# Service Bulletin

Bulletin No.: 23-NA-135

**Subject: Information on Oil Level Control Changes and Compatibility on 2023-2024 9-Speed Transmissions**

6396979

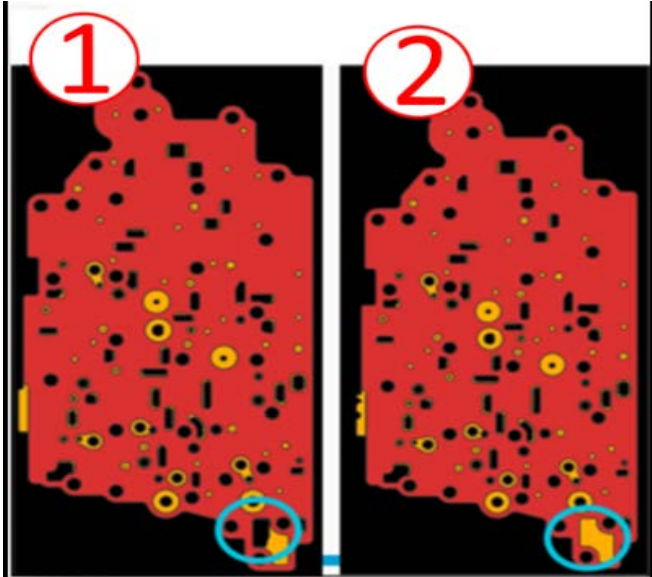
- 1) For use in model year 2023 and prior (w/OLC).
- 2) For use in model year 2024 and forward (w/o OLC).

The valve body will eliminate the a/trans fluid valve (item #437 and #436).

6397367

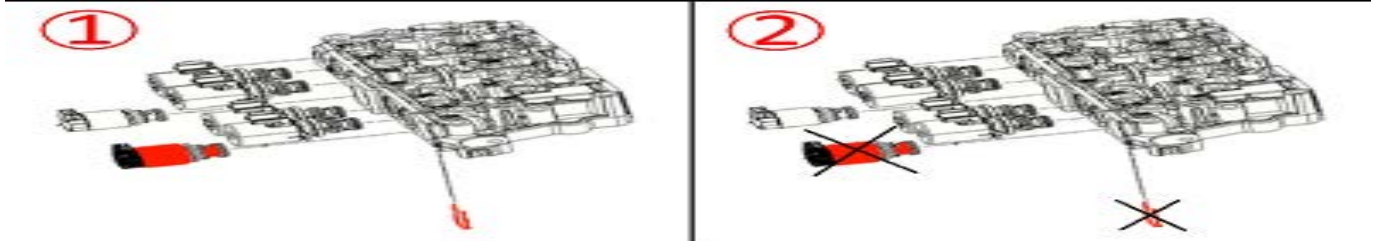
- 1) For use in model year 2023 and prior (w/OLC).
- 2) For use in model year 2024 and forward (w/o OLC).

The valve body to transmission case spacer plate is covering over the port (item #456).

6397498

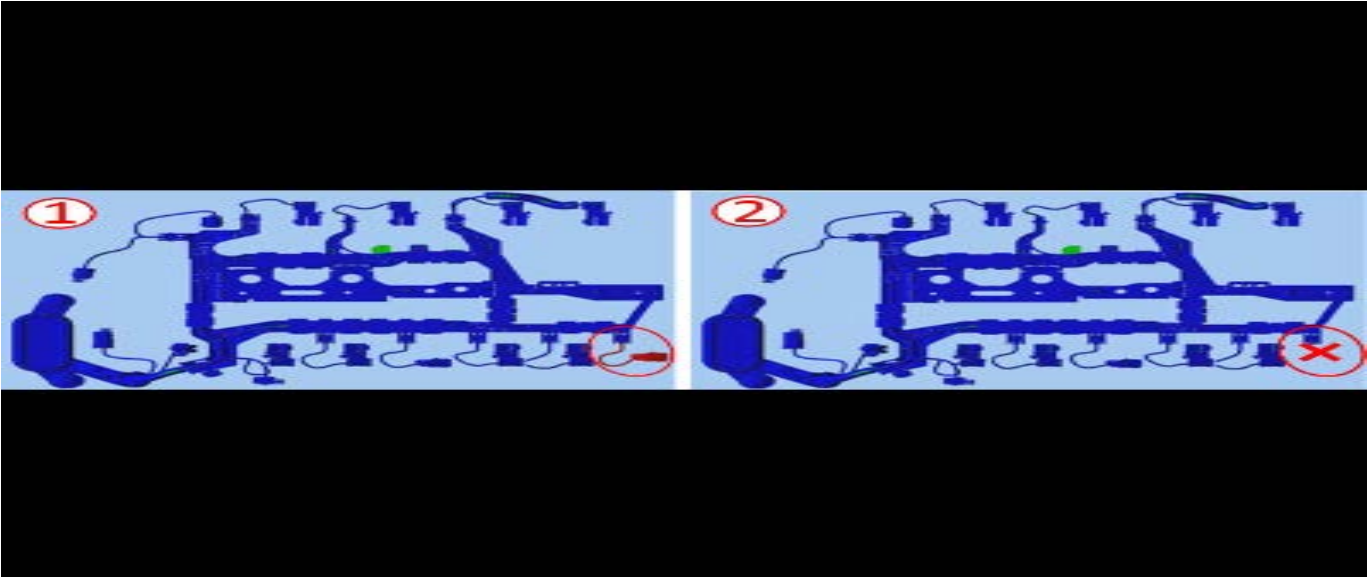
- 1) For use in model year 2023 and prior (w/OLC).
- 2) For use in model year 2024 and forward (w/o OLC).

The solenoid body will eliminate the a/trans fluid control solenoid (item #403).

6397499

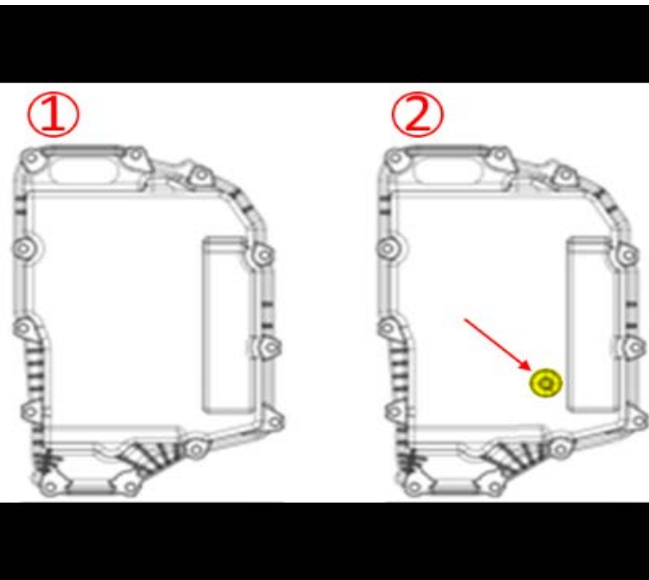
- 1) For use in model year 2023 and prior (w/OLC).
- 2) For use in model year 2024 and forward (w/o OLC).

The a/trans wiring harness will eliminate the wire for the a/trans fluid control solenoid (item #31).
